AMENDMENTS PROPOSED IN ACCORDANCE WITH THE BUILDING ACT 2004

Additional and Addendum to Newport Surf Life Saving Club

Project NEWPORT SURF LIFESAVING CLUB REBURFISHMENT				www.ppp.com.au ppp@ppp.com.au Phone: 75 000 00 00
	Title SUGGESTED STRENGTHENING OF EXISTING BUILDING				
20180141	Drawn by ST.1	Revised by R3	Date 18.10.24	By EM

SK-01  
15/11/24

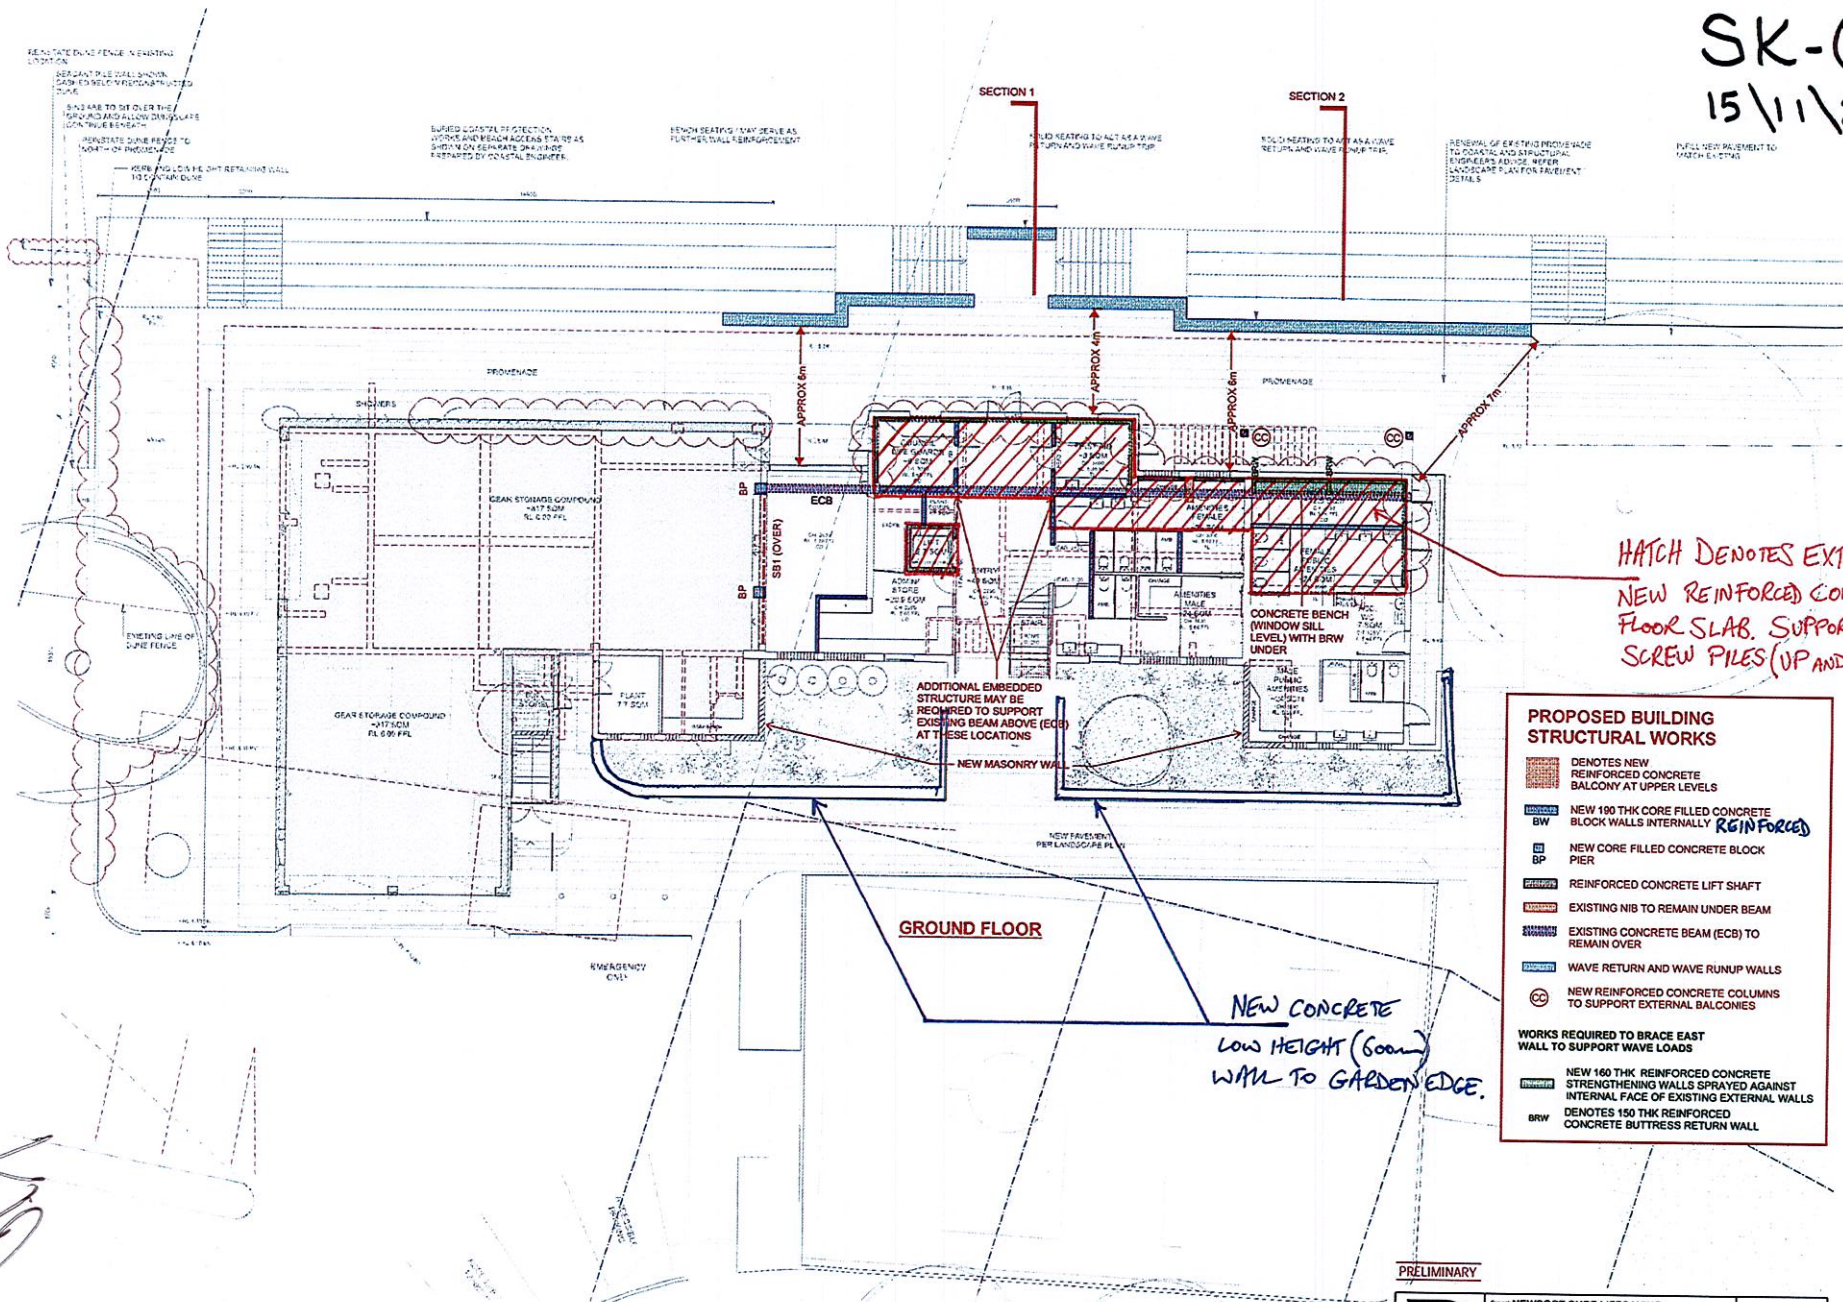
HATCH DENOTES EXTENT OF NEW REINFORCED CONCRETE FLOOR SLAB. SUPPORT ON SCREW PILES (UP AND DOWN)

NEW CONCRETE LOW HEIGHT (600mm) WALL TO GARDEN EDGE.

SK-02  
15/11/24

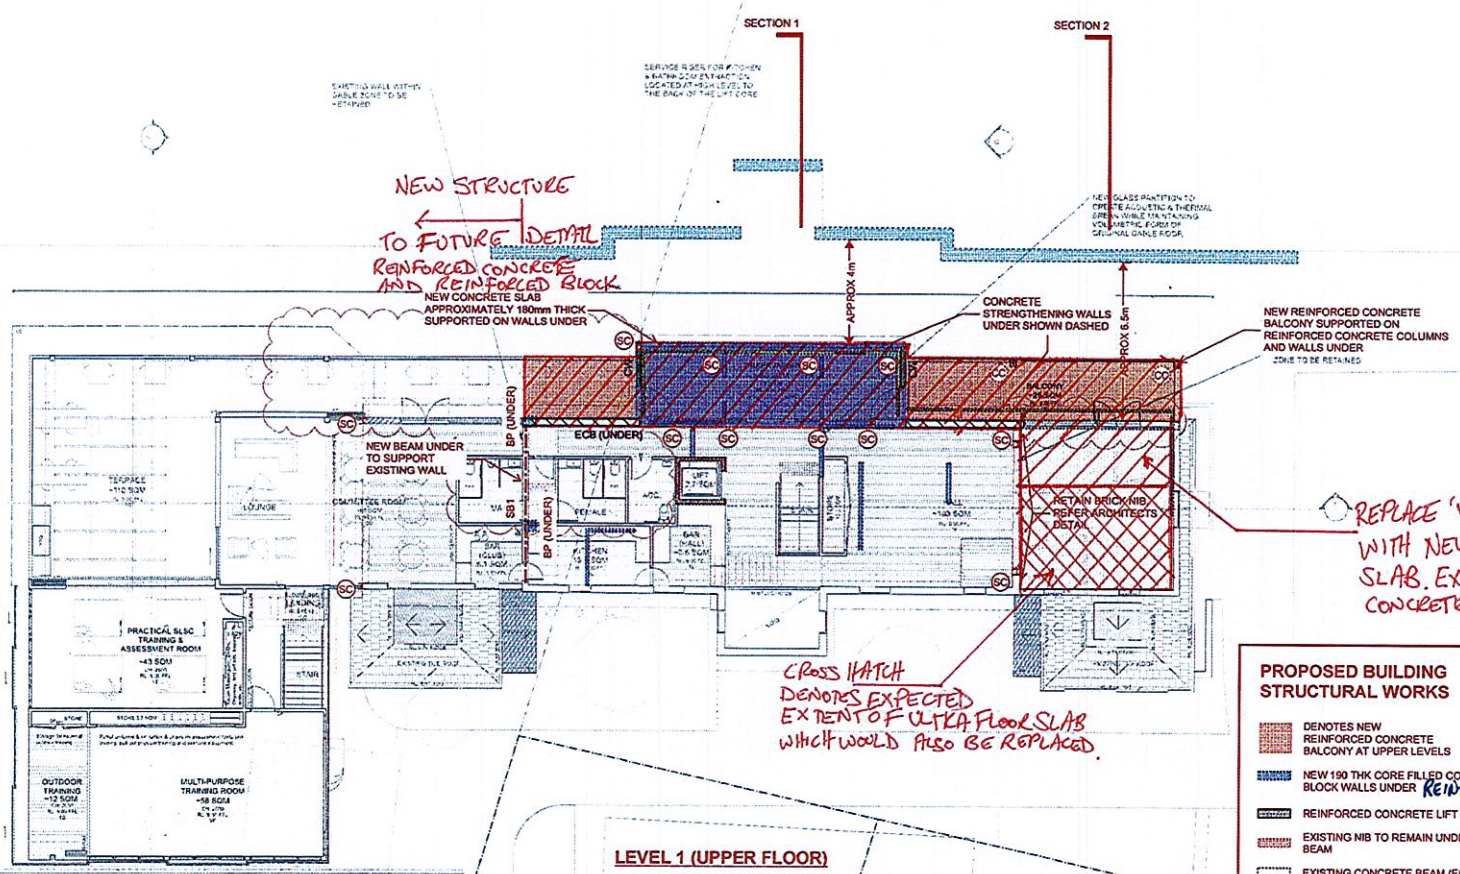
NEW STRUCTURE  
TO FUTURE DETAIL  
REINFORCED CONCRETE  
AND REINFORCED BLOCK  
NEW CONCRETE SLAB  
APPROXIMATELY 180mm THICK  
SUPPORTED ON WALLS UNDER

REPLACE 'ULTRA FLOOR' SLAB  
WITH NEW REINFORCED CONCRETE  
SLAB. EXTENT OF NEW AND REPLACEMENT  
CONCRETE SHOWN HATCHED.

CROSS HATCH  
DENOTES EXPECTED  
EXTENT OF 'ULTRA FLOOR' SLAB  
WHICH WOULD ALSO BE REPLACED.
